Puhoi to Warkworth

N1A Remediation Options - Technical Review Comments

P2WK-TAS-GE-TM-0010 | A

Waka Kotahi NZTA

Figure 1 Screen capture of NX2's January 2023 drone flyover, with sketches of approximate locations of (a) March 2020 N1A landslide (b) current N1A landslide (c) prehistoric landslide. View towards the south-west.

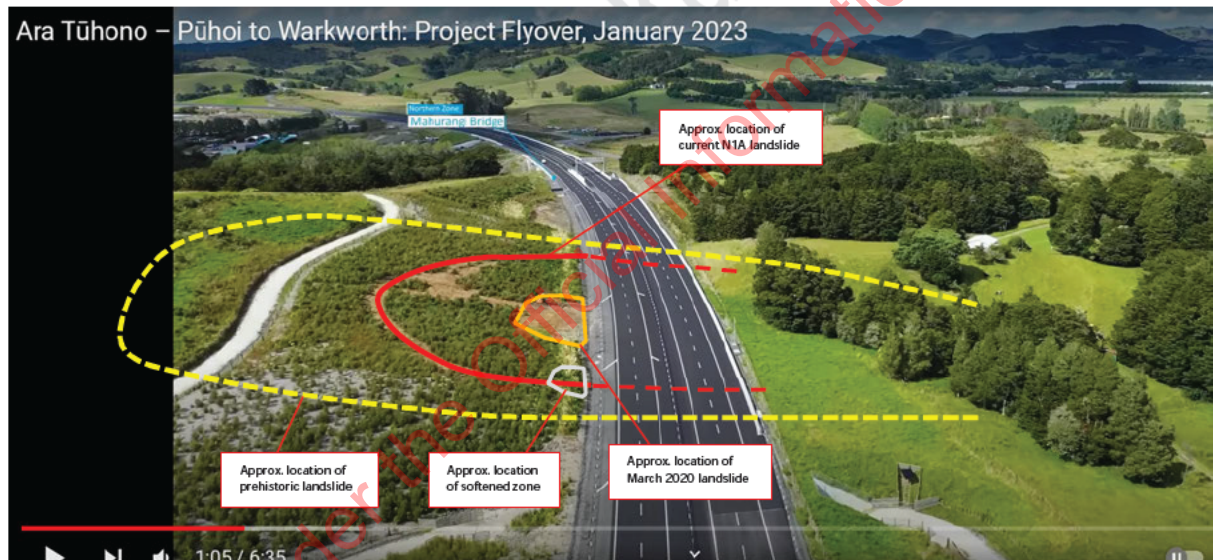
- A pre-historical landslide feature has reactivated on the N1A cut slope east of the carriageway (a reactivated slow-moving translational earth slide). As displacement increases, there is an increased risk of water ingress into the slope from the dilation of tension cracks near the landslide headscarp.

- A noticeable bulge has developed at the toe of the cut slope, with mobilised material squeezing and closing up the swale drain and a slight bulging of the edge of the shoulder³. The depth of engineered fill under the main carriageway is likely acting as a reinforced volume and encouraging some compression and upward movement of the landslide mass at this location.

Figure 2 NX2 Option 1 section.

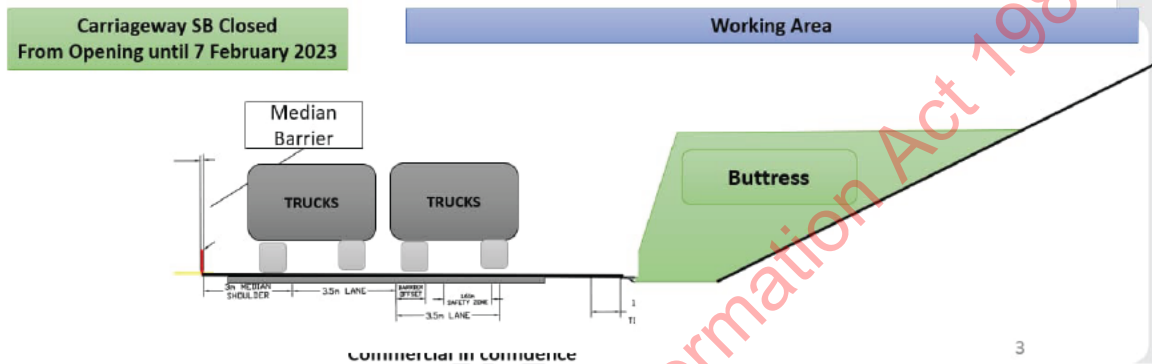
- Option 1 involves placement of a fill buttress at the base of the cut slope.
- In their presentation NX2 have shown an interpreted ground model section with two landslide slip surfaces at depth extending beneath the carriageway (Figure 2). The deepest shear surface is interpreted to be at a depth of about 6-8m below the base of the buttress. Therefore, if option 1 was implemented as shown by NX2 the buttress will not be ‘keyed’ into stable bedrock at depth.

- The performance of the buttress to stabilise the landslide when not keyed into stable bedrock requires a very robust knowledge of the ground model, slip surfaces and the landslide behaviour, with as many uncertainties as possible eliminated.

Figure 3 NX2's stability section for Option 1

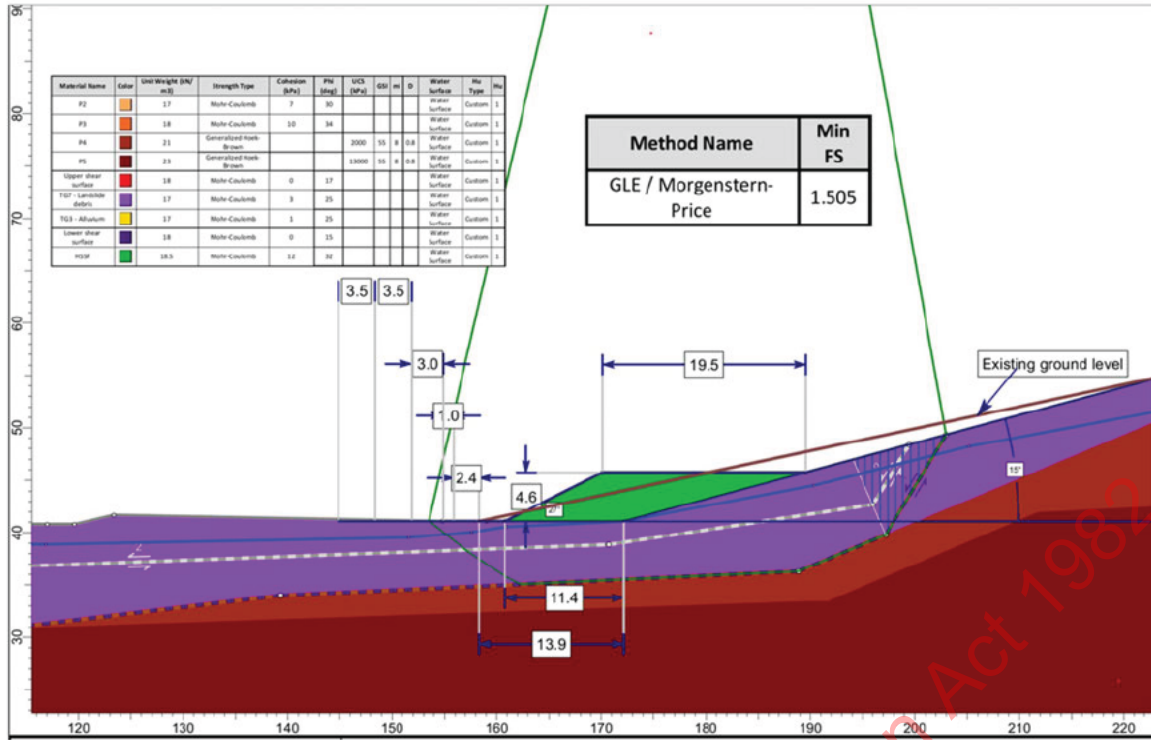
- While reprofiling the cut slope removes some of the material in the upper part of the cut, and the buttress acts as a toe buttress to further stabilise landslides involving the slope (red slip surfaces in Figure 3), there is the risk that the buttress destabilises potential slip surfaces existing beneath the carriageway (purple slip surfaces in Figure 3).

- Thus there is a risk that a fill buttress could have both positive and negative effects.

Figure 5 Options 2 and 3 section

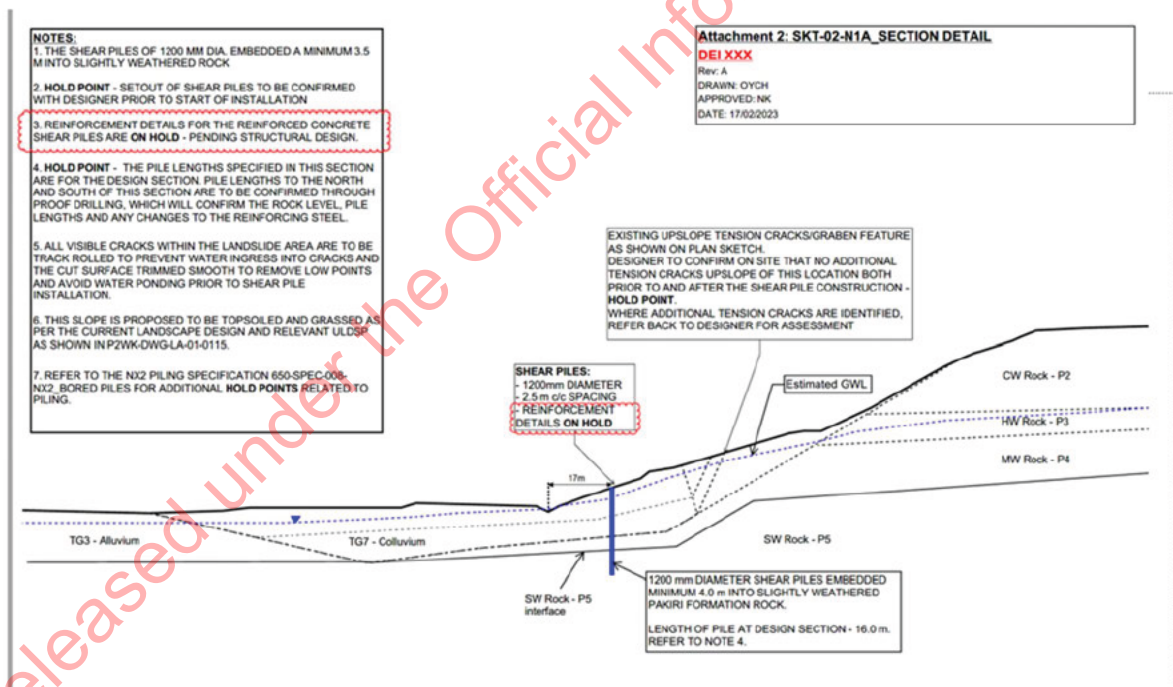
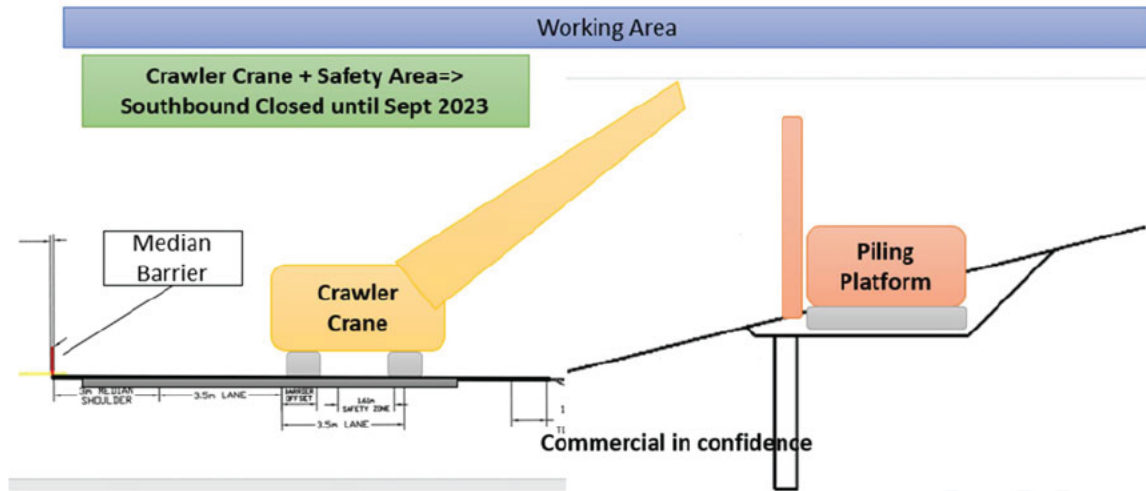
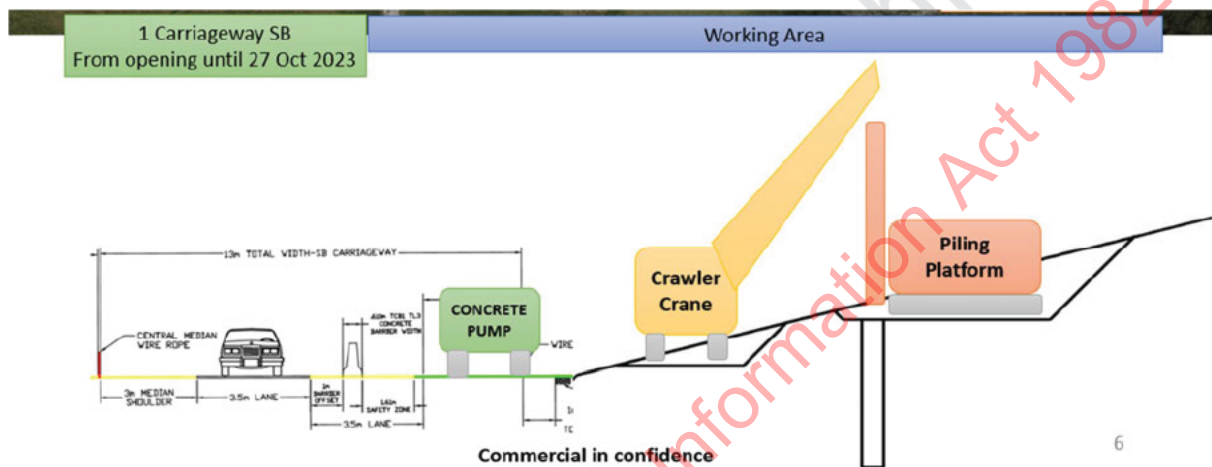
- The piled solutions involve providing a restraining force to the upslope portion of the landslide, and effectively reduces the driving force on the lower portion of the landslide. The slip surfaces are positively intercepted and reinforced.

- The potential instability on gently inclined slip surfaces to the west of the piles and beneath the carriageway is likely decreased. Although the landslide body and slip surfaces here would remain unrestrained, and therefore the remaining instability of the downslope landslide mass should be investigated and confirmed during detailed design.

- It is essential that the piles are embedded into underlying stable rock well below the lower slip surface. This would require a knowledge of the geometry of the lowermost slip surface in the direction along the row of piles. We note that the NX2 presentation shows a proposed hold point to confirm the pile lengths through proof drilling. TAS agrees with this approach and would recommend that adequate proof drilling is carried out in advance of the construction in order to adjust or confirm the design based on the drilling results.

- The lifting radius of a crane operating from the motorway for Option 2 will likely require a large crane. The surface of the motorway would need to be protected if the motorway is used as a crane platform. Any requirements to stop adjacent (live) traffic during lifting operations will also need to be factored in.

- The minimum width for the piling platform is anticipated to be around 6-8m to allow for safe operations. Temporary cuts for the platform will need to be excavated such that they do not exacerbate the existing slope instability.

Figure 8 Modified NX2 sketch to show potential rock anchor option for consideration

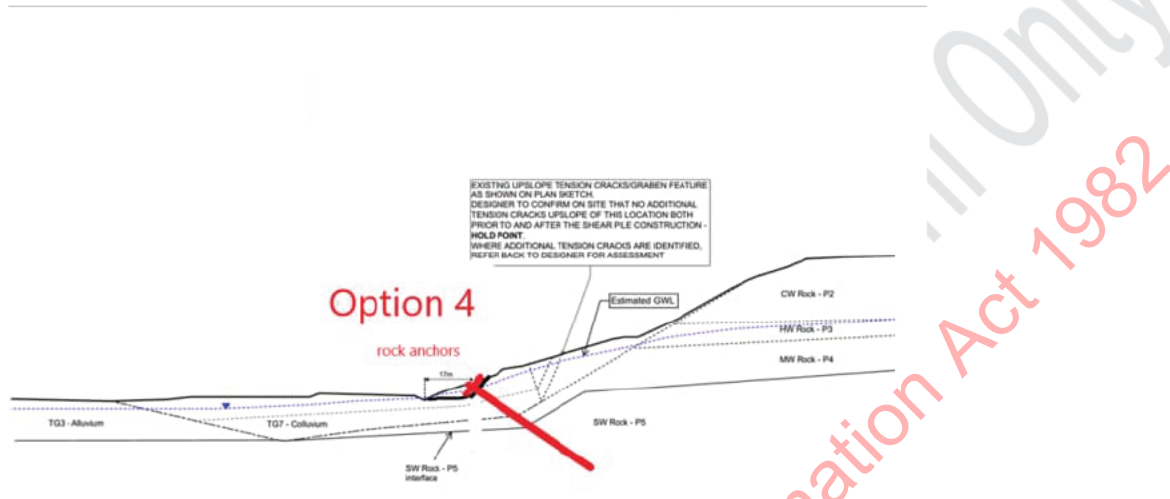
As an alternative deep rock anchors could be investigated as a possible solution requiring works to be performed along either one or two platforms on the slope face similar to Options 2 and 3. A second platform may be required if two rows of rock anchors are needed rather than a single row of rock anchors. The anchors would need large concrete pads to transfer anchor loads into the landslide mass. We expect that road closures for this option would be similar to that required for Option 3. Installation of rock anchors is likely to require smaller plant than that for Options 2 & 3.

A risk with Option 4 is that a better understanding of anchor founding conditions through further ground investigations would be required so that when installation of the anchors begin the risk of longer anchors being required is minimal. Trial anchors would need to be drilled and load tested to confirm anchor design prior to construction.
